Chittagong Fashion Specialized Textiles Ltd

Building Observations

Incomplete & Out of Date Drawings

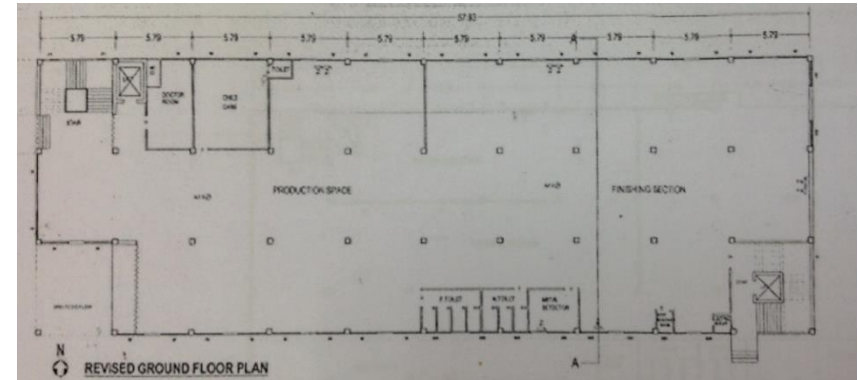
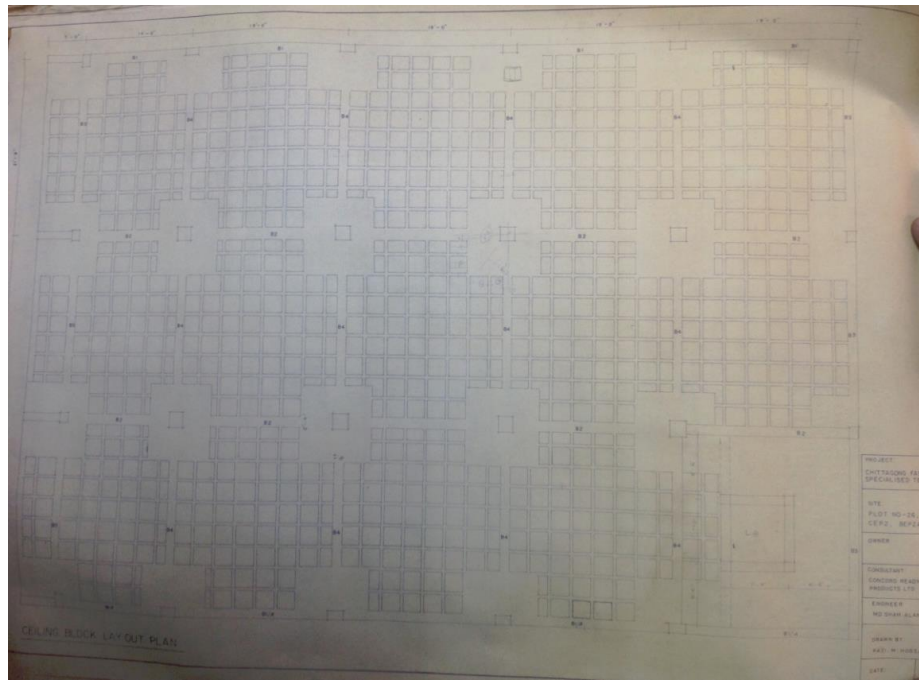
Structural drawings provided were incomplete and do not fully represent the as-constructed building structure

Structural drawings show a single structural system rather than the as- built structure which is effectively two separate but interconnected buildings with different structural systems.

Column grid dimensions in the East – West direction do not correspond between the permit drawings and the as- built structure.

Cracking on underside of East Block floor slab

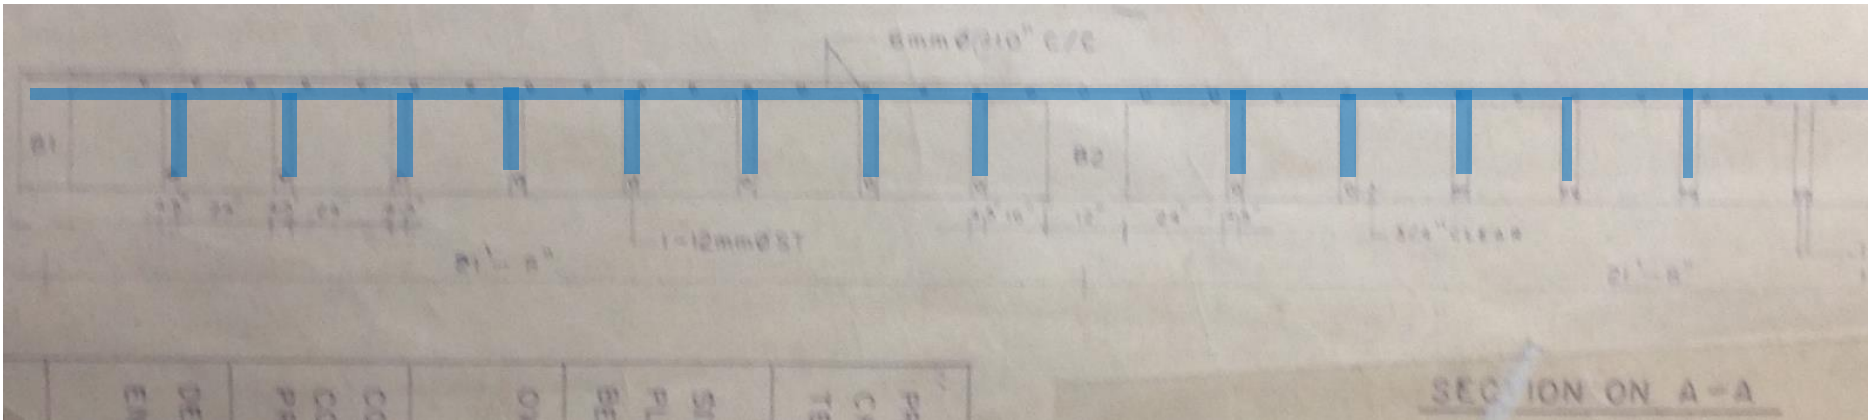
East Block floors appeared initially to be of flat slab construction. Long, relatively straight cracks could be seen on the slab soffits throughout the building – primarily running east-west but with some running north-south. There were often two or more cracks running parallel to each other.

Drawings indicate that a waffle slab has been constructed. The Factory engineer advised that waffles had been in-filled by permanent brickwork. This may be reflective of the crack lines. We are unclear how the brickwork is retained in position on the slab soffit.

Building Engineer to review and confirm that the above is correct and advise how brick formwork is retained in position to ensure that the slab soffit cracking does not develop further.
